MIL "ON" DTC P014C, P014D, P014E, or P014F

Service Category Engine/Hybrid System

Section Engine Control

YEAR(S)	MODEL(S)	ADDITIONAL INFORMATION
2010 – 2012	IS250	Transmission(s): 6AT
2010 – 2012	IS250C	Transmission(s): 6AT

Figure 1. Location of Authorized Modifications Label on 2010 – 2012 IS 250/250C

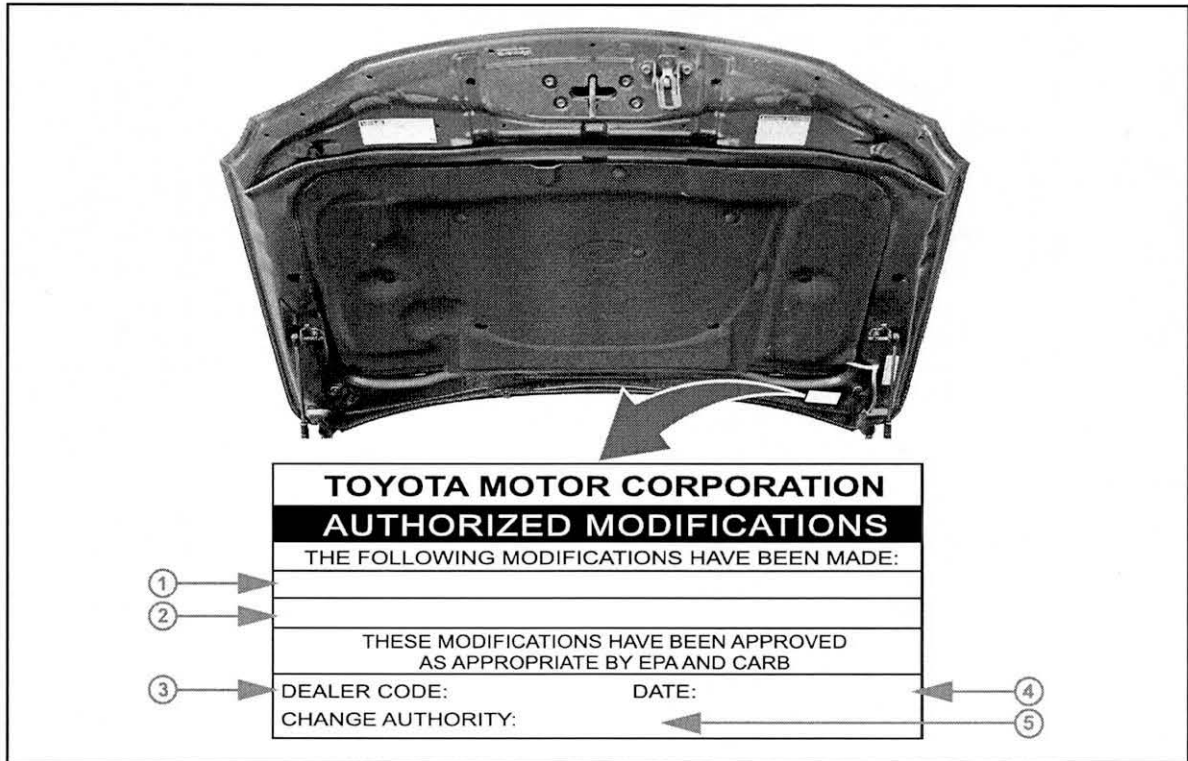
2. Check for the Authorized Modifications Label affixed to the vehicle in the location shown in Figure 1. Confirm if the ECM (PCM) calibration has been updated. If the calibration ID listed is NOT the latest ECM (PCM) calibration — go to step 3.

4. Install the Authorized Modifications Label.
 - A. Using a permanent marker, enter the following information on the label:
 - ECM part number [Refer to the **Parts Information** section for the **CURRENT PART NUMBER**]
 - Calibration ID(s) [Refer to the **Calibration Identification Chart** for the **NEW CALIBRATION ID**]
 - Dealer Code
 - Repair Date
 - Change Authority [**This bulletin number**]
 - B. Affix the Authorized Modifications Label to the vehicle at the location shown in Figure 1. The Authorized Modifications Label is available through the MDC, P/N 00451-00001-LBL.
5. Test drive the vehicle to confirm proper vehicle operation.
